Planning Commission Meeting
Thursday, September 25, 2014
Meeting held at the Saratoga Springs City Offices
1307 North Commerce Drive, Suite 200, Saratoga Springs

**Site Plan and Conditional Use
Vista Heights (LDS Church Building)
September 25, 2014
Public Hearing**

Report Date:	September 18, 2014
Applicant/Owner:	Evans and Associates Architecture
Location:	612 West Pony Express Parkway
Major Street Access:	Pony Express Parkway
Parcel Number(s) & Size:	66:300:0009 (~4.59 acres)
Parcel Zoning:	R-3, Low Density Residential
Adjacent Zoning:	A, PC
Current Use of Parcel:	Vacant
Adjacent Uses:	Middle School, Agricultural
Previous Meetings:	Minor Subdivision review by PC, 6-12-11 Concept Plan review by PC, 6-12-14 Concept Plan review by CC, 7-1-14
Previous Approvals:	Minor Subdivision approved by CC, 7-5-11
Land Use Authority:	City Council
Future Routing:	Public meeting with City Council
Author:	Sarah Carroll, Senior Planner

This is a request for review of a Site Plan and Conditional Use Permit for the Vista Heights Stake Center, located at 612 West Pony Express Parkway. The site includes a church building, a pavilion, a storage building, and associated parking and landscaping.

Sheet:
C4.11

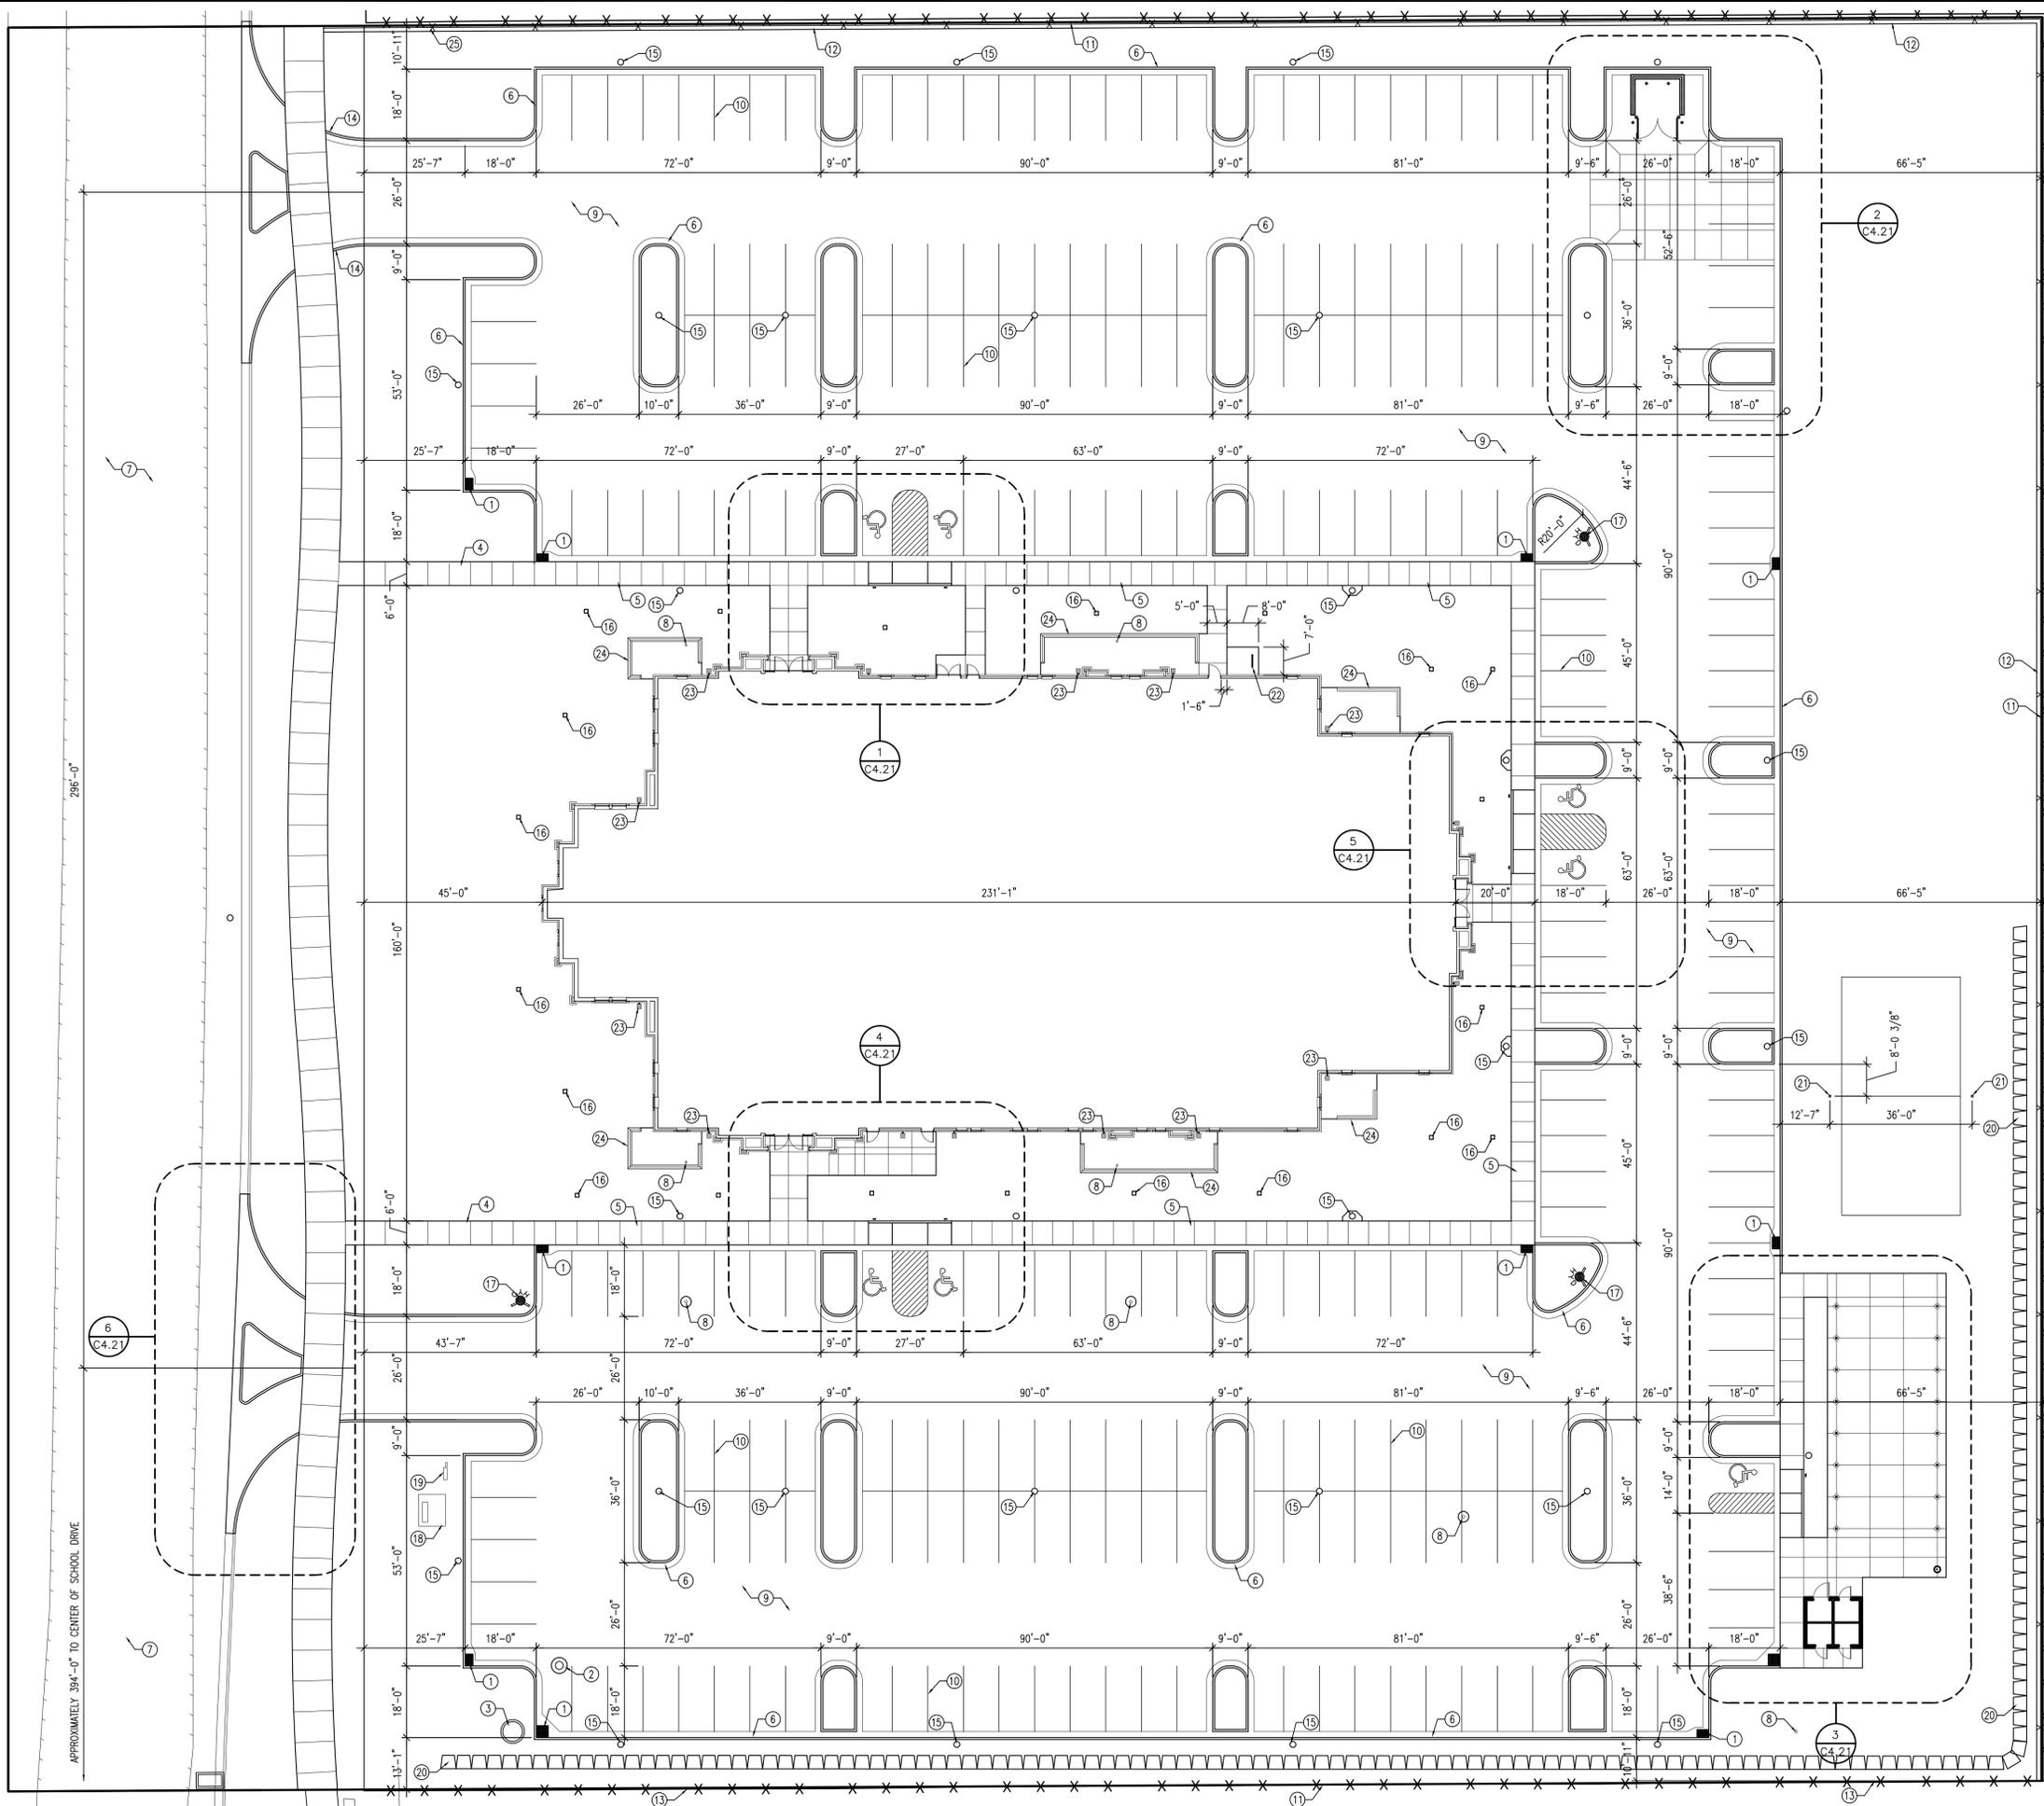
Fencing: complies. Section 19.06.09 requires fencing along property lines abutting open space, parks, trails, and easement corridors. In addition, fencing may also be required adjacent to undeveloped properties. On Sheet C4.11, notes 12 and 13 are related to fencing and indicate that the chain link fence on the east property line will remain, and the chain link fence on the north and west property lines will be replaced with a six foot tall vinyl privacy fence; thus, meeting the requirement for fencing adjacent to undeveloped properties.

Sheet Title
MECHANICAL AND DUMPSTER ENCLOSURE DETAILS

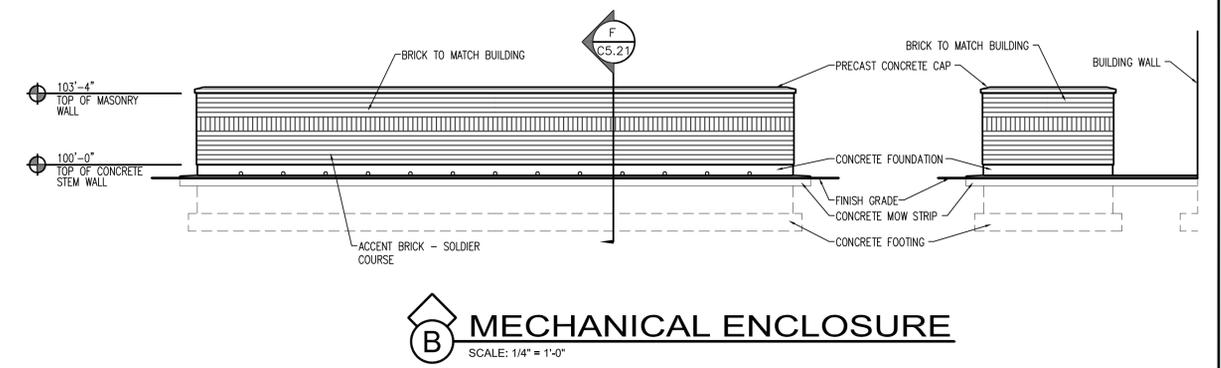
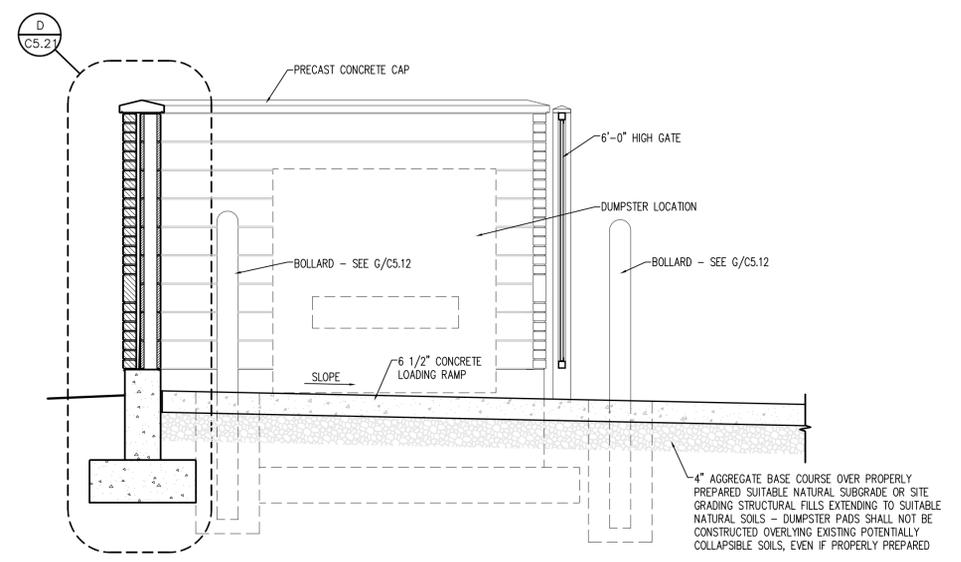
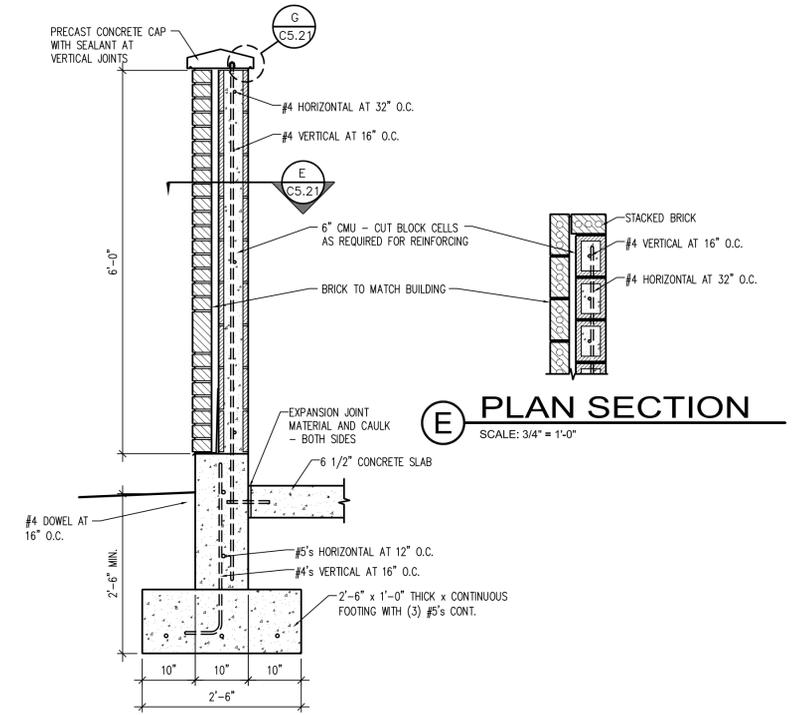
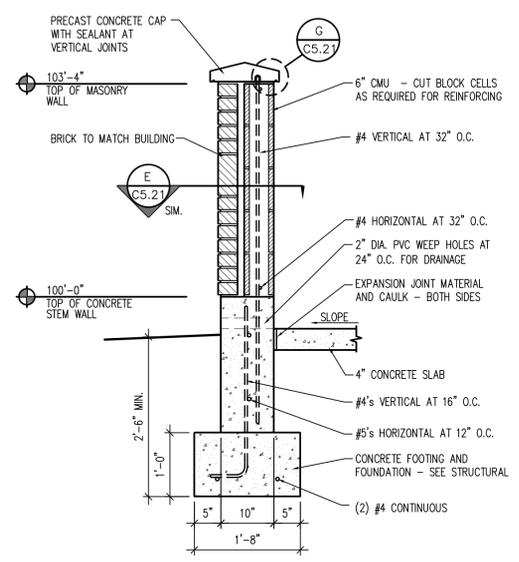
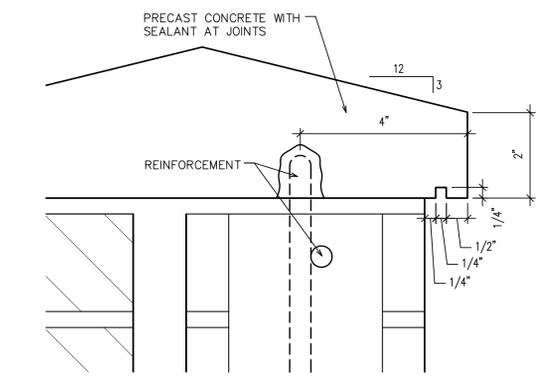
Trash storage: complies. Section 19.14.04 requires trash storage areas to be comparable with the proposed building and surrounding structures. Sheet C5.21 includes details for the dumpster enclosure and it meets these requirements.
